Project No. 2022\_110

## Midlothian ISD Baxter ES Kitchen Upgrades

### ADDENDUM NO. 2

March 20, 2023

2 REDUCED PRESSURE BACKFLOW PREVENTER DETAIL  
NO SCALE

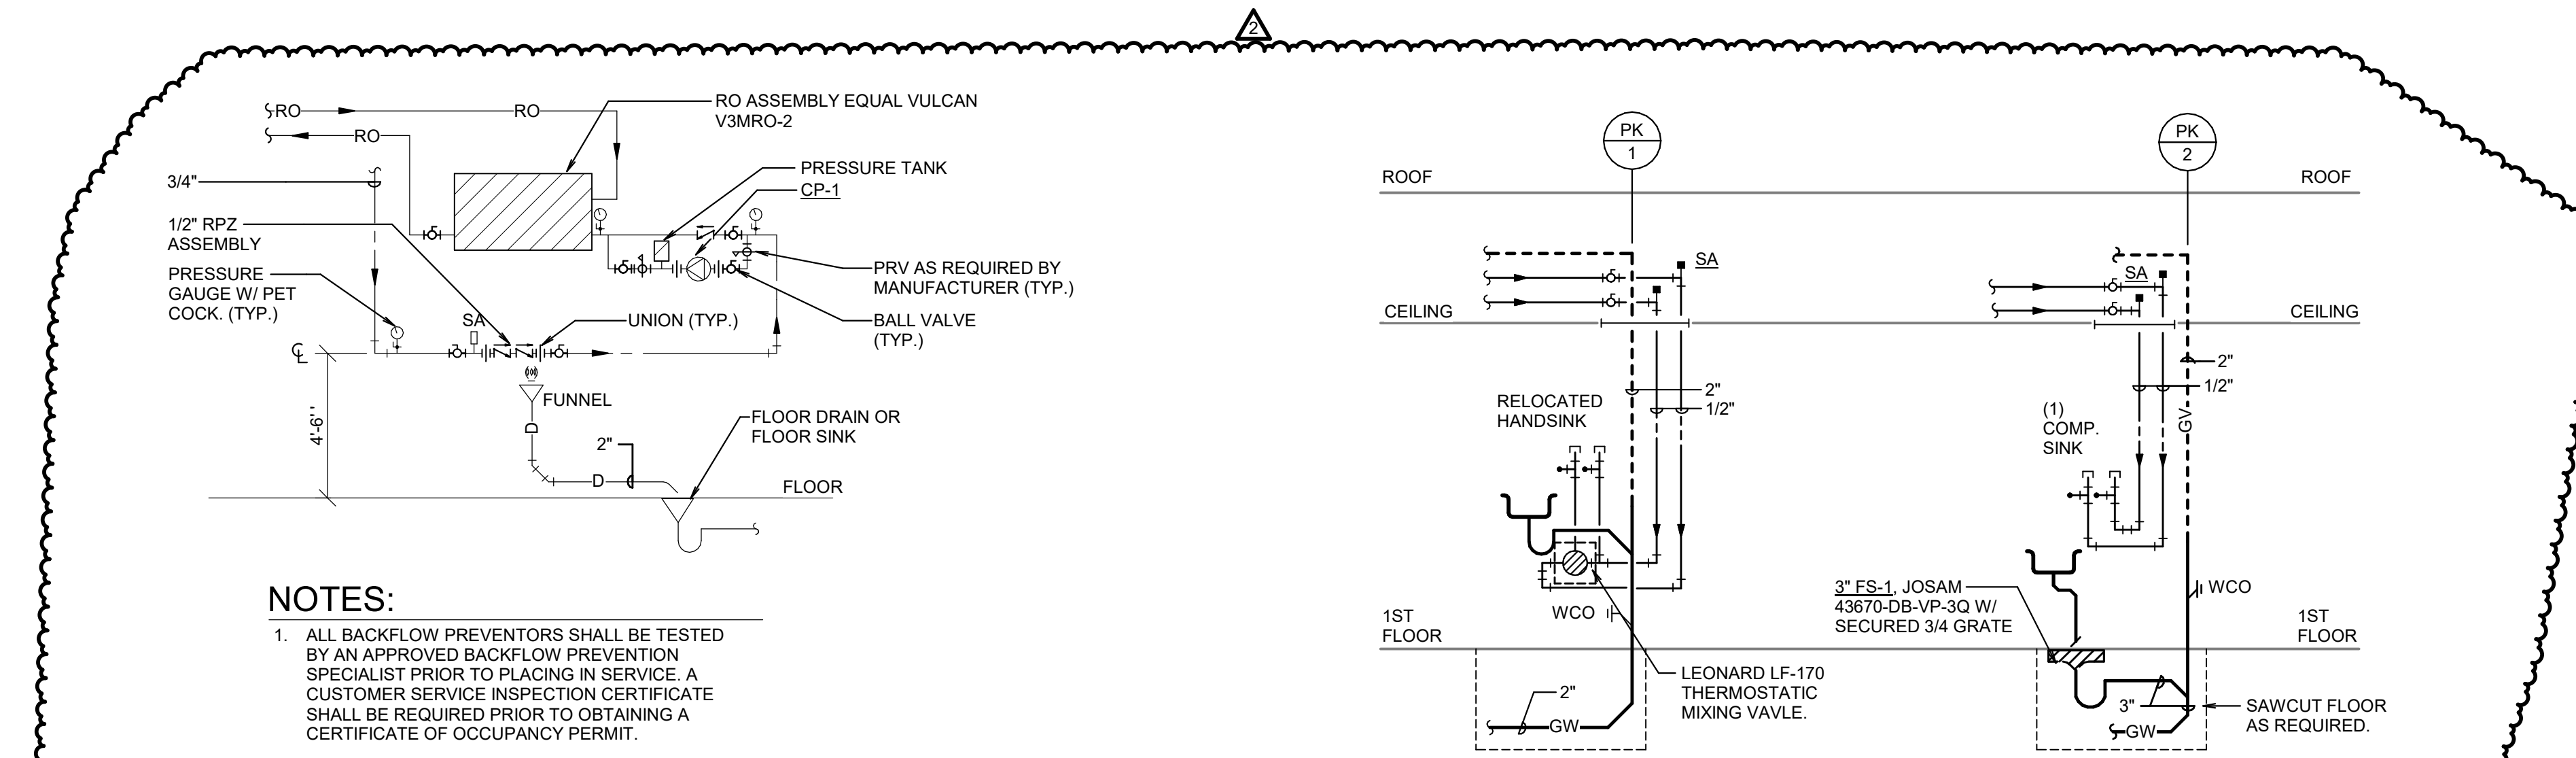
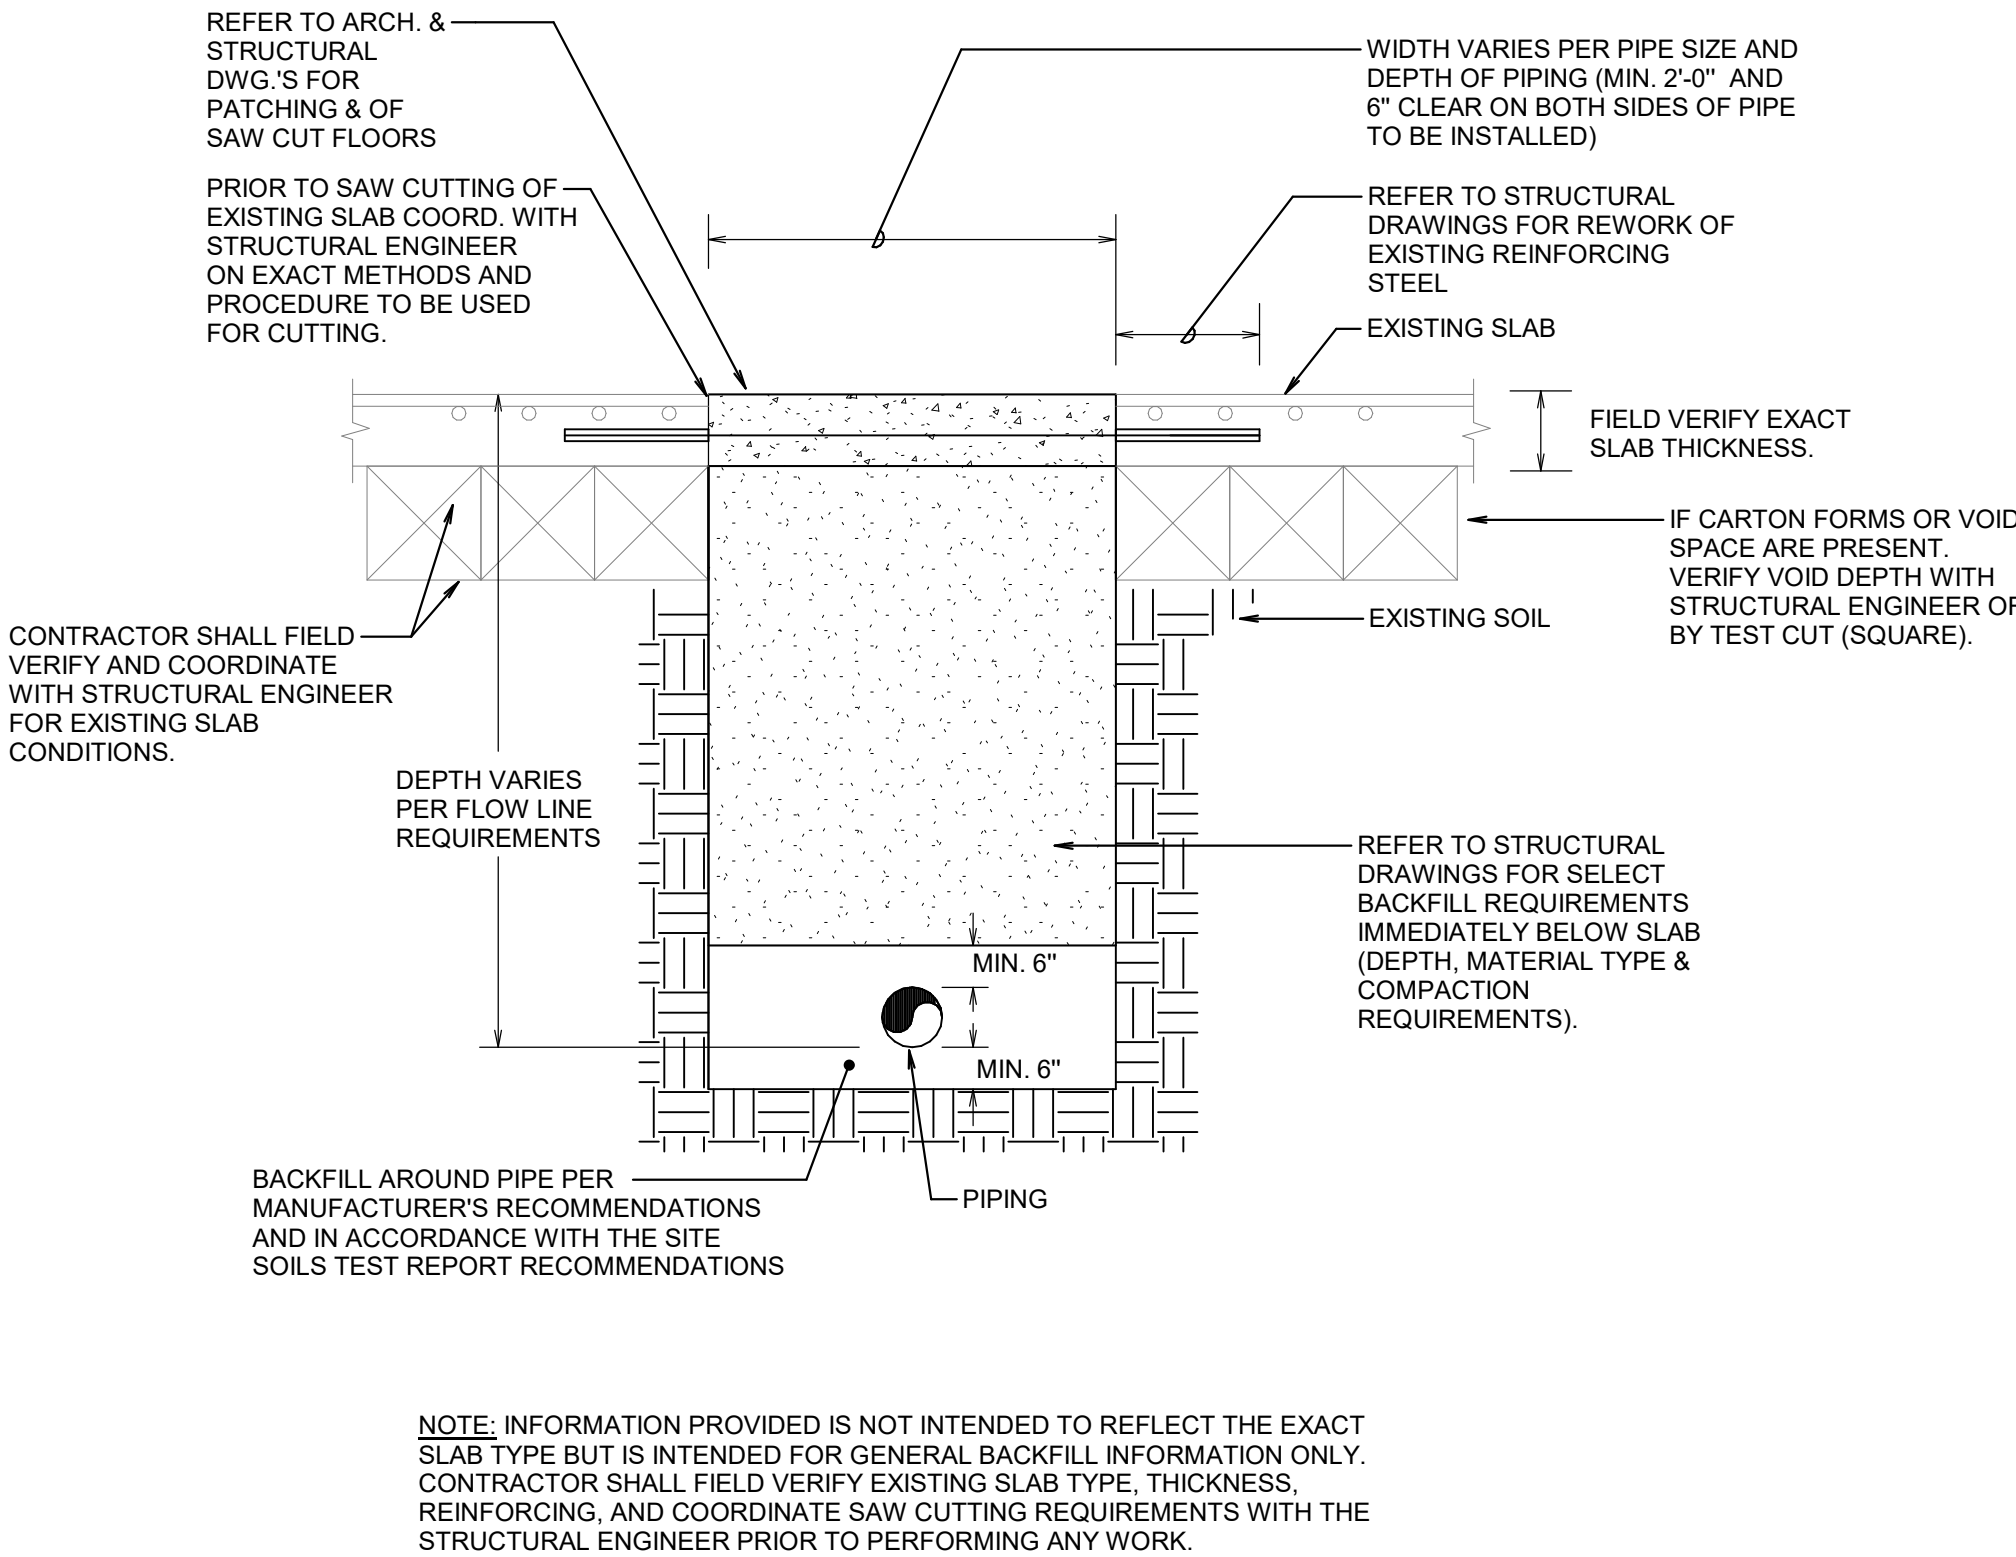
ITEM NO. 05 P000 – PLUMBING SPECIFICATIONS, LEGENDS, & NOTES

- A. Refer to attached plan for revisions.
